**From:** [REDACTED]  
**To:** [REDACTED]  
**CC:** [REDACTED]  
**Sent:** 2/24/2021 5:29:11 PM  
**Subject:** RE: O8W-PM [REDACTED] - Bucks Creek 1101 Phase 1,2&3 - Pre-Engineering Meeting  
**Importance:** High

# Bucks Creek 1101- PM# 35217268 Overview Map

Subject: O8W-PM [REDACTED] - Bucks Creek 1101 Phase 1,2&3 - Pre-Engineering Meeting

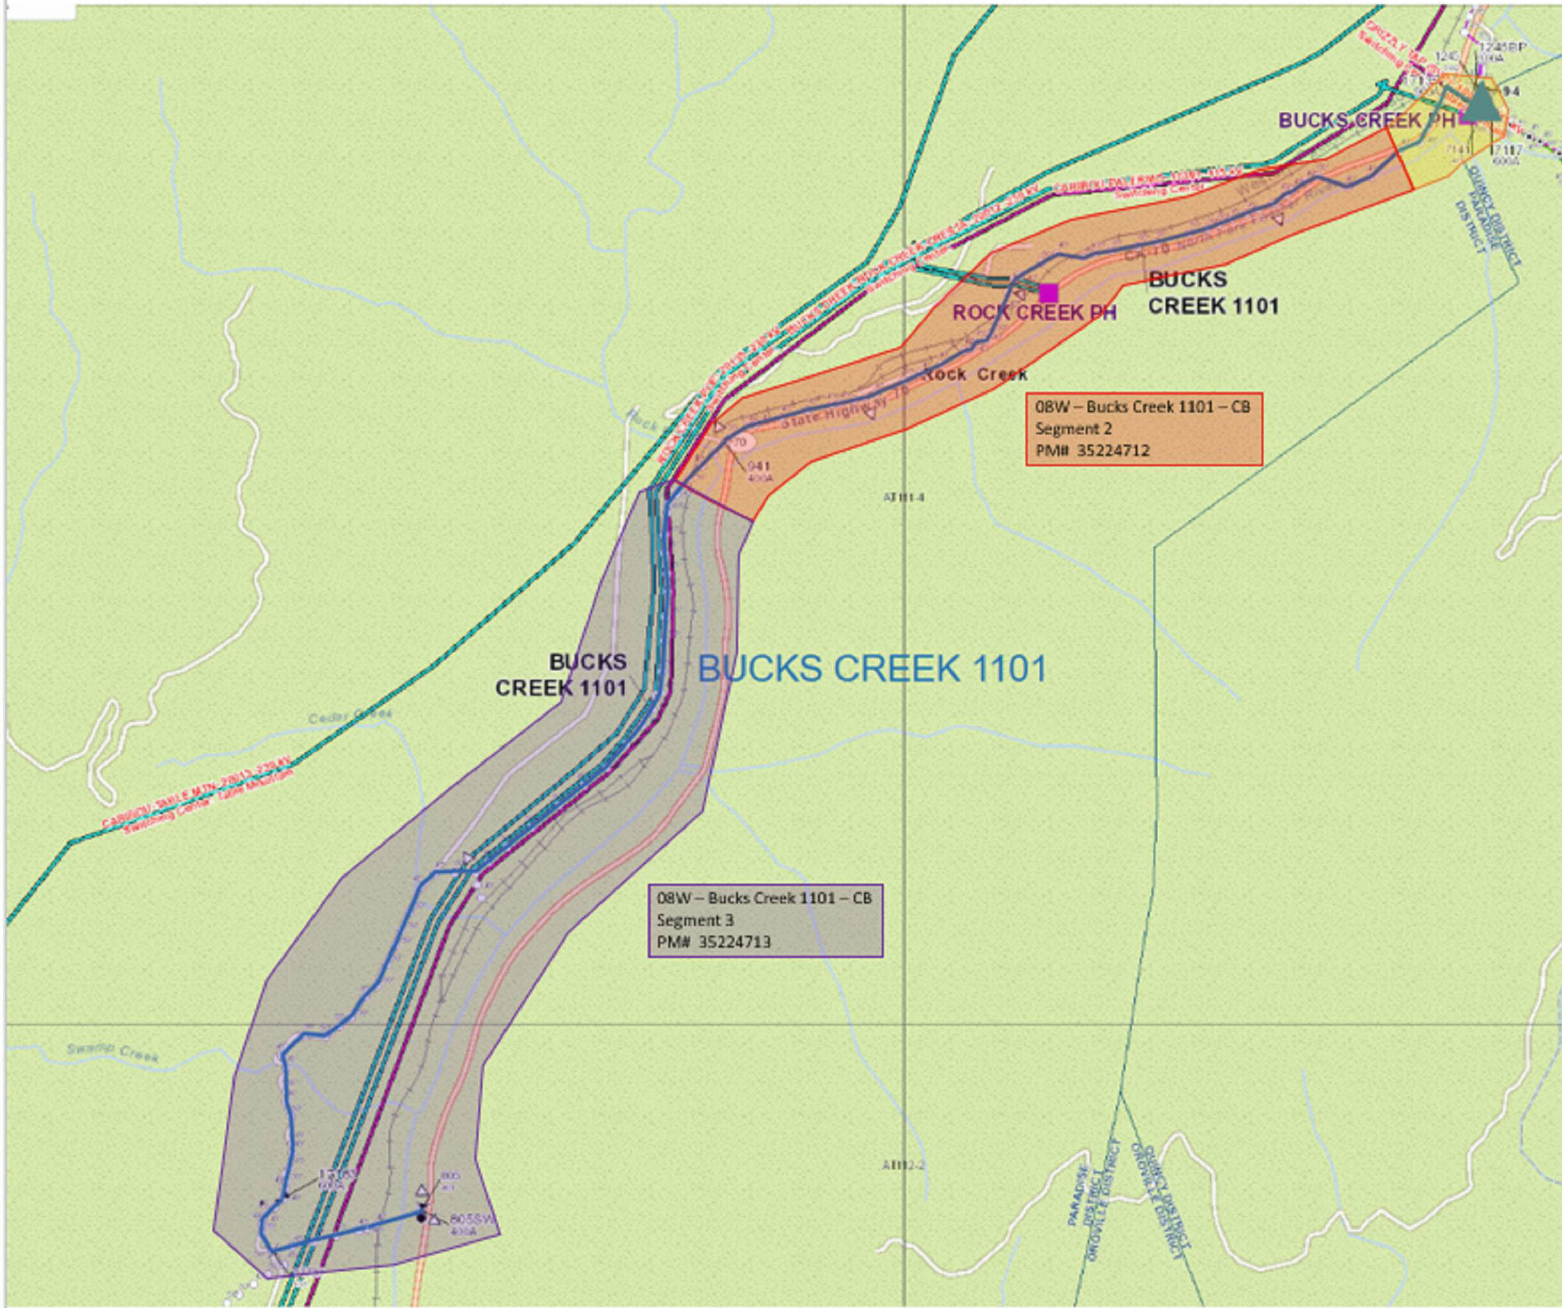
For Bucks Creek there is quite a bit of work surrounding Hwy 70 and we will need a Land Department

Base Maps prepared for all 3 Orders. This will delay the EOD dates until these can be developed and provided to the Vendor... We will also need answers to the questions outlined by Travis below...
